REQUESTOR NAME: **BC Sustainable Energy Association**

INFORMATION REQUEST ROUND NO: 2

TO: **FortisBC Inc. (FBC)**

APPLICATION NAME: **Application for a Certificate of Public Convenience and Necessity (CPCN) for the Advanced Metering Infrastructure (AMI) Project**

Figure 1 – Source: *The Canadian Smart Grid Standards Roadmap: A strategic planning document, Standards Council of Canada, October 2012, Section 5.2, Page 27, Figure 5 (Exhibit B-11, BCSEA #IR1 3.1); [with red, orange, blue arrows and purple ovals added for emphasis]*

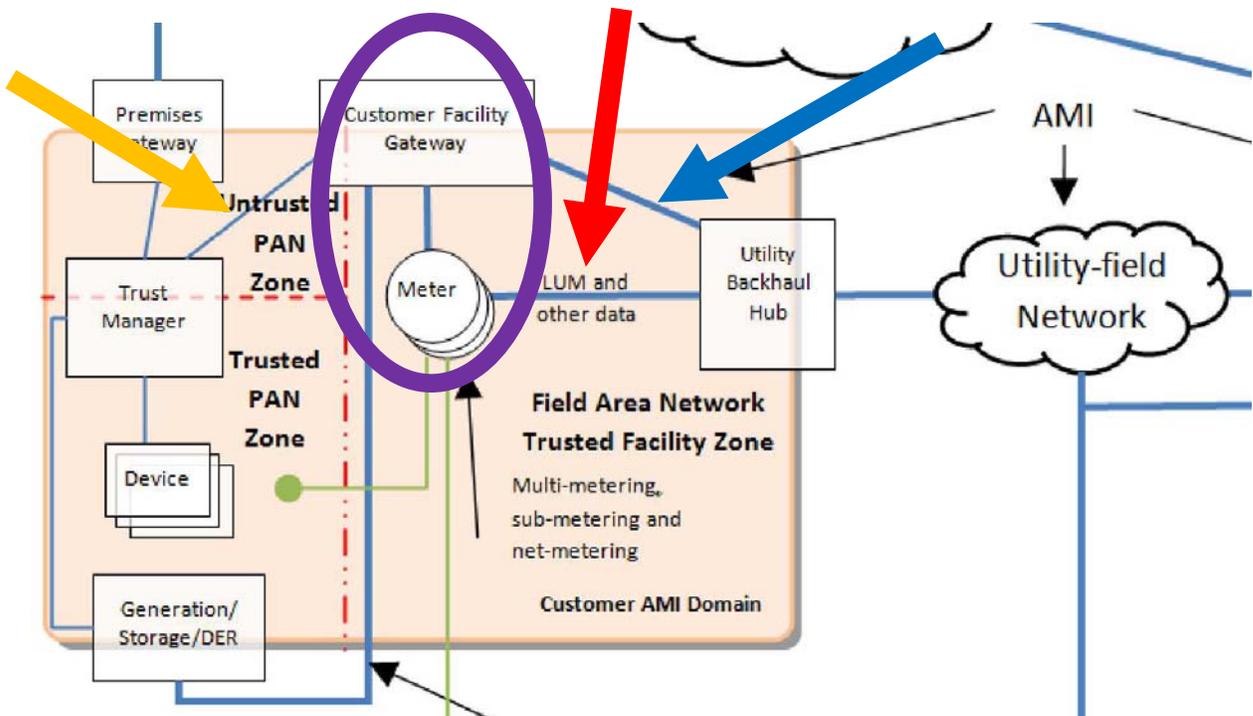
94.1 Would FortisBC agree that the information listed in Exhibit B-11, BCSEA IR #1 2.5 (page 7) is depicted by the Orange Arrow in Figure 1, above? If not, please explain.

- 94.2 Considering that the “Logical AMI Diagram” shows a logical architecture, would FortisBC agree that the integrated Zigbee Technology is generally described by the “Customer Facility Gateway” in the diagram? If not, please explain.

- 94.3 Does FortisBC agree that the storing of ANSI C12.19 energy information⁵ is contained within the “Meter” as shown in Figure 1 above and is used for both sending information to the head end (Red Arrow) and to the IHD (Orange Arrow)? If not, please explain.

- 94.4 Please compare the translation process, computation requirements and storage requirements needed to transmit the ANSI C12.19 energy information back to the head end (Red Arrow) versus to the IHD (Orange Arrow).

- 94.5 Please confirm that “electricity pricing” information will be transmitted from the LAN to the Smart Meter (including the Zigbee card) as depicted by the Blue Arrow.

Figure 2 – Source: *The Canadian Smart Grid Standards Roadmap: A strategic planning document*, Standards Council of Canada, October 2012, Section 5.2, Page 27, Figure 5 (Exhibit B-11, BCSEA #IR1 3.1); [with red/blue broad arrow added for emphasis]

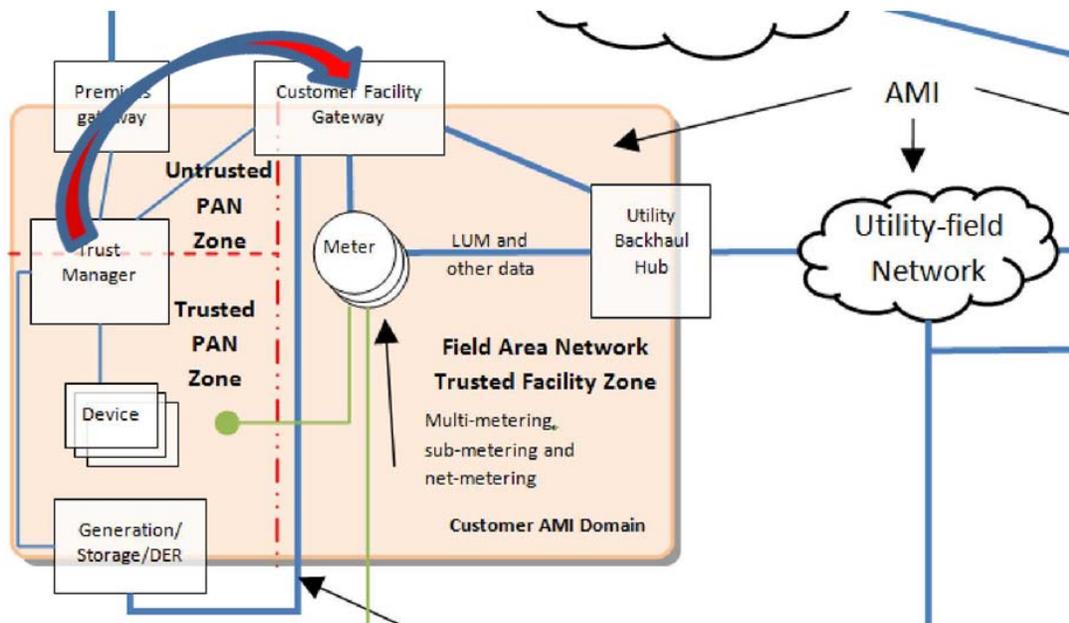
95.1 Looking at Figure 2 above, would FortisBC agree that the proposed Itron AMI solution shifts the “Trust Manager” function to the “Customer Facility Gateway” position as noted by the broad red/blue arrow. If not, please explain. If agreed, please answer the following questions:

95.1.1 Please discuss the ramifications of doing so from a privacy and security point of view.

95.1.2 Please discuss how FortisBC would meet the M1 Recommendation of the Task Force.

95.1.3 Please explain how “a clear and unambiguous separation (demarcation) between utility-owned and customer-owned equipment and services” is accomplished.

95.2 If the customer had the Network Coordinator within their own premises and their own control, would FortisBC agree that the “Trust Manager” could remain as shown in Figure 2. If not, please explain. If agreed, please answer the following questions:

95.2.1 Please discuss the ramifications of this solution on the privacy and security considerations.

95.2.2 Please discuss how this solution would meet the M1 Recommendation of the Task Force .

95.2.3 Please explain how this solution provides “a clear and unambiguous separation (demarcation) between utility-owned and customer-owned equipment and services” .
